Access Compliance Report

Public Rights-of-Way

(Curb Ramps)

Intersection ID: 51751	Main Street: GOLF_LINKS_DR	Cross Street: GOLF_LINKS_DR_N	Location: NE
ADA ID: 591FD18D9AC2	Ramp Type: PerpDiag	Initial Pass/Fail: Fail	Overall Compliance: No
Severity Score: 21.25			
Codes/Mitigation Info/Possible Solution		Field Measurements/Component Compliance

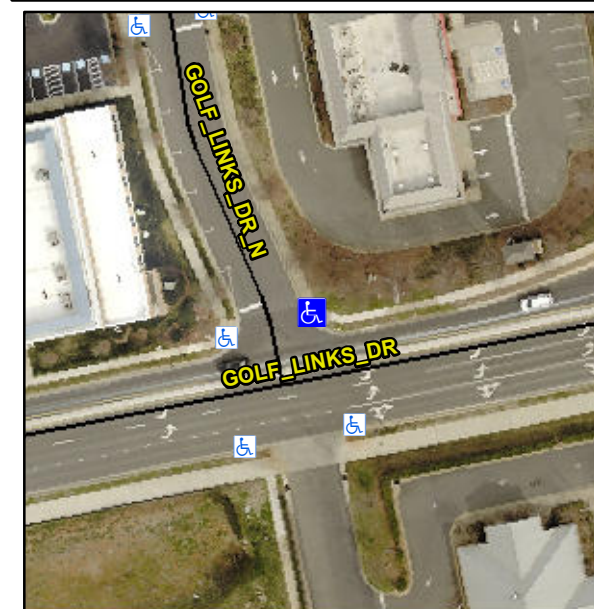
Not Found, R304.5.1, R304.5.3

Compliance	Description	Data	Compliance	Description	Data
N/A	Ramp Length (in)	47.0	Yes	Ramp Slope (%)	7.9
No	Ramp Width (in)	40.0	No	Ramp XSlope (%)	5.8
N/A	Flare Type LT	N/A	N/A	Flare Type RT	N/A
N/A	Flare Slope LT (%)	N/A	N/A	Flare Slope RT (%)	N/A
N/A	Flare Traversable LT?	N/A	N/A	Flare Traversable RT?	N/A
N/A	Landing Length (in)	N/A	N/A	DWS Provided?	N/A
N/A	Landing Width (in)	N/A	N/A	DWS Contrast?	N/A
N/A	Landing Slope (%)	N/A	N/A	DWS Length (in)	N/A
N/A	Landing X Slope (%)	N/A	N/A	DWS Full Width?	N/A
N/A	Landing Curb? (Y/N)	N/A	N/A	DWS Offset (in)	N/A
N/A	Shared Landing?	N/A			
N/A	Gutter Ponding?	N/A	N/A	Gutter Slope (%)	N/A
N/A	Gutter Lip Ht (in)	N/A	N/A	Gutter X Slope (%)	N/A
N/A	Painted X Walk1?	No	N/A	Painted X Walk2?	No
	X Walk 1 Direction	To W		X Walk 2 Direction	To S
N/A	X Walk 1 Width (in)	N/A	N/A	X Walk 2 Width (in)	N/A
	X Walk 1 Slope (%)	5.9		X Walk 2 Slope (%)	0.3
	X Walk 1 X Slope (%)	2.8		X Walk 2 X Slope (%)	3.7

Remove & Replace Curb Ramp With Two New Directional Ramps or Equivalent.
